Report of the CAA's Post Implementation Review of the London Airspace Management Programme (LAMP) Phase 1A Module D Airspace Change Proposal – London Luton Airport: Standard Instrument Departure (SID) Switch Proposal

CAP 1692 D

Annex B - Module D – Luton & Northolt SID switch proposal, usage and CAA analysis of change

ACP Figure 1: Pre-change Luton, Northolt departure situation

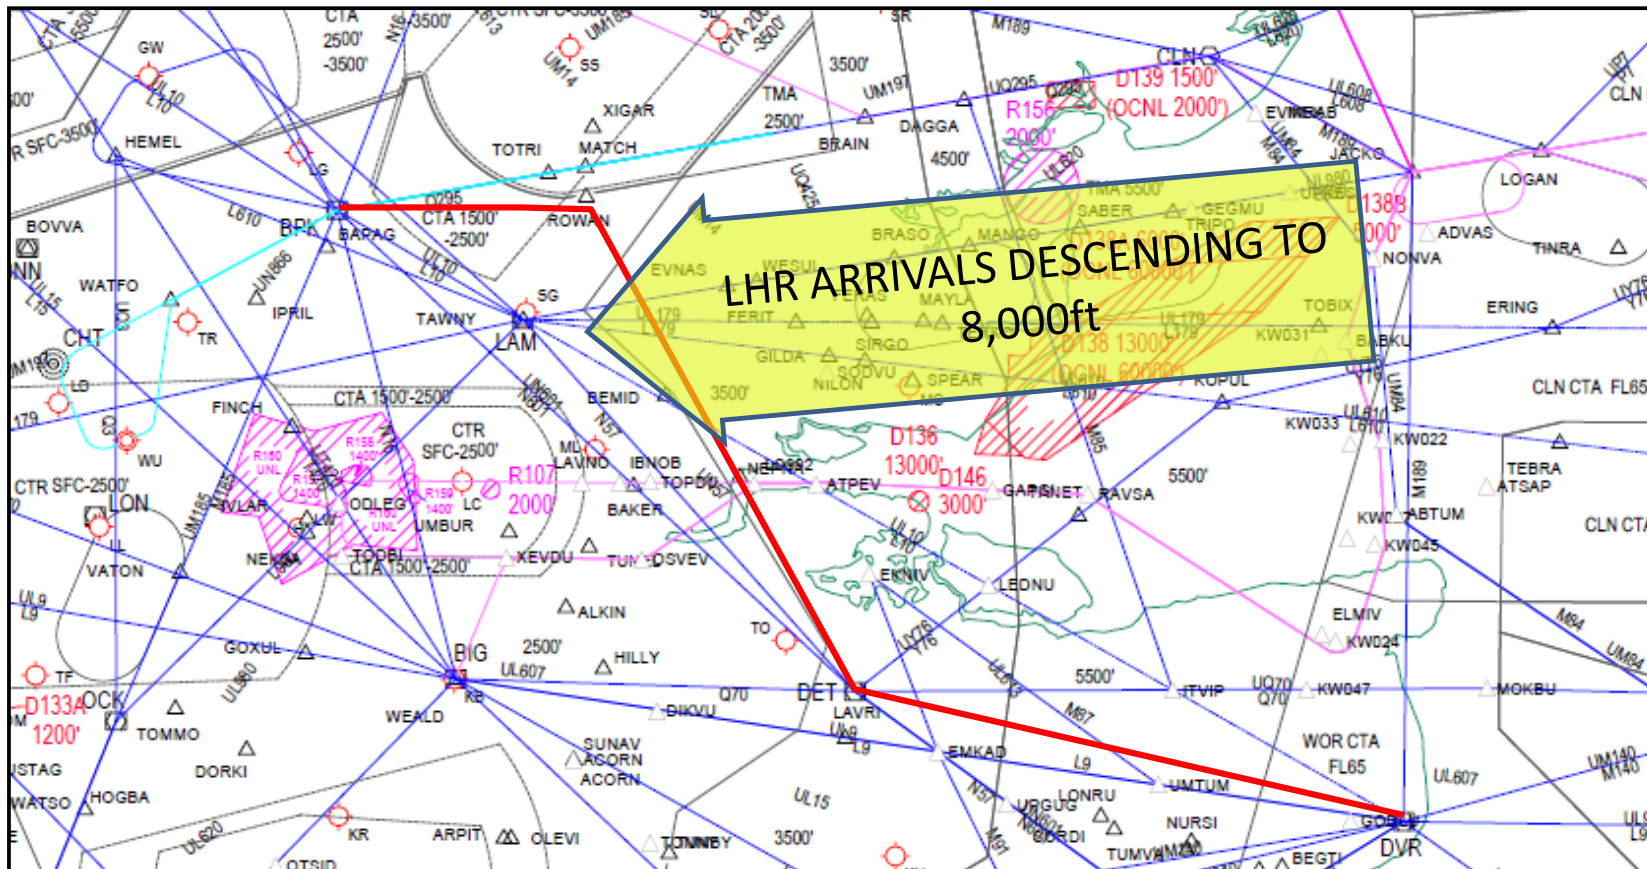
From the ACP diagrams reproduced below from the ACP Fig 3, all MATCH SIDs track to Brookmans Park (BPK) VOR (navigation beacon) then route eastbound to MATCH (a navigation waypoint at Matching Green), then towards Clacton on ATS route Q295, although traffic is predominately radar vectored before BPK due to other interacting traffic and do not always follow the precise SID routeing after BPK.

All Detling (DET) SIDs track to BPK, then route towards the east for approximately 10NM before turning towards Detling, after which they either route to Dover or Lydd as appropriate, although traffic is predominately radar vectored due to other interacting traffic and do not always follow the precise SID routeing prior to or after BPK.

ACP Figure 2: Proposed Luton, Northolt departure situation

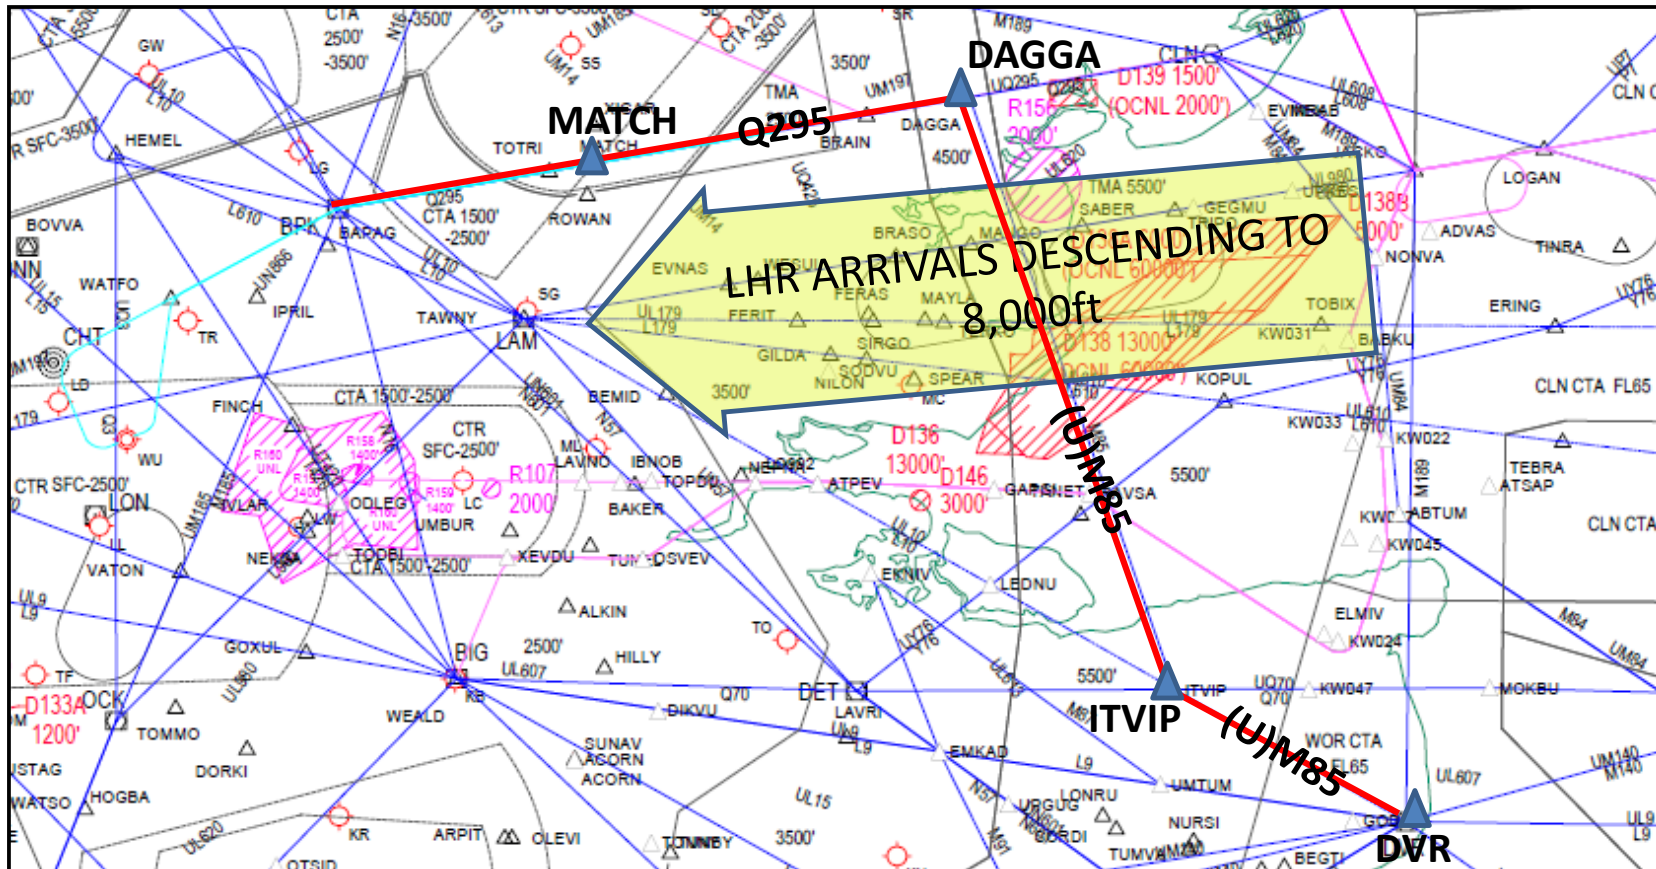
The SID switch re-routing (reproduced below from the ACP Fig 4) illustrated that departures would follow the routing towards Clacton using the MATCH SID, but at a position DAGGA, they would then join a new route (M85) towards ITVIP then Dover (DVR) then resume the pre-change routes to leave UK airspace.

After the change, NATS forecast that in practice, most Luton and Northolt departures were expected reach FL150 before DAGGA and would be tactically turned off the Q295 on a southerly heading when they were sufficiently above any conflicting Heathrow traffic.

Variation in climb performance and conflicting Heathrow traffic would result in a spread of flights turning south from Q295. This spread would be from around MATCH out to DAGGA. The tactical turn south would generally be at levels between FL150 and 200 – as shown in Figure 5 below which is data taken from the ‘Real Time’ simulation before the change.
